Compliance Dept. Compliance Dept.
SERVICE PROCEDURE

19518
JANUARY, 2020

SUBJECT: SAFETY RECALL
Stationary PTO on certain International® HV™ and MV™ Series, DuraStar®, and WorkStar® models built 12 January 2017 thru 24 September 2019 with feature code 12VXT (Engine Speed Control; Electronic, Stationary, Variable Speed) or 12VXU (Engine Speed Control for PTO; Electronic, Stationary Preset, Two Speed Settings)

Figure 1. PTO Parameters

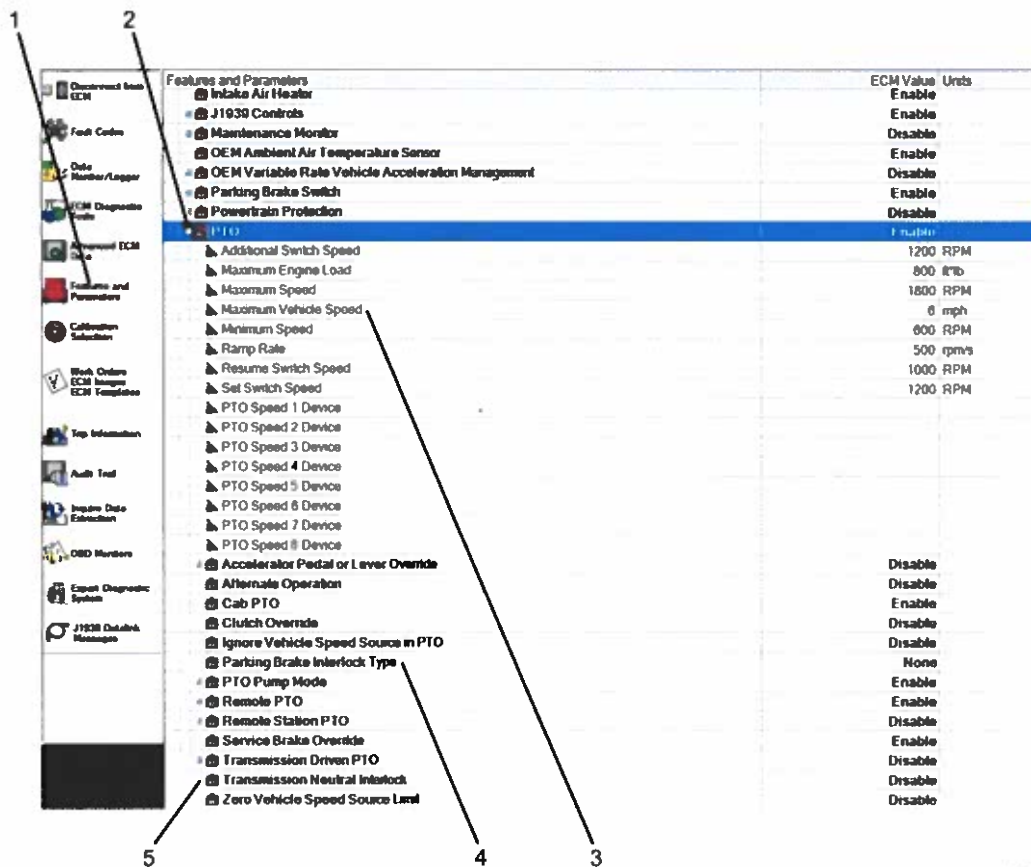
On certain trucks equipped with an automatic transmission, if the automatic transmission is still in drive or reverse position and the stationary PTO switch is engaged, the engine rpm could ramp up and may overcome parking brake hold capability resulting in possible vehicle movement. Unexpected movement of the truck can increase the risk of a crash resulting in property damage or personal injury.

9. Select FEATURES AND PARAMETERS button (Figure 1, Item 1).

10. Scroll to PTO menu (Figure 1, Item 2).

- a. Maximum Vehicle Speed: 2 mph (3.2 km/h) (Figure 1, Item 3).
- b. Parking Brake Interlock Type: ALL (Figure 1, Item 4).
- c. Transmission Neutral Interlock: ENABLE (Figure 1, Item 5).
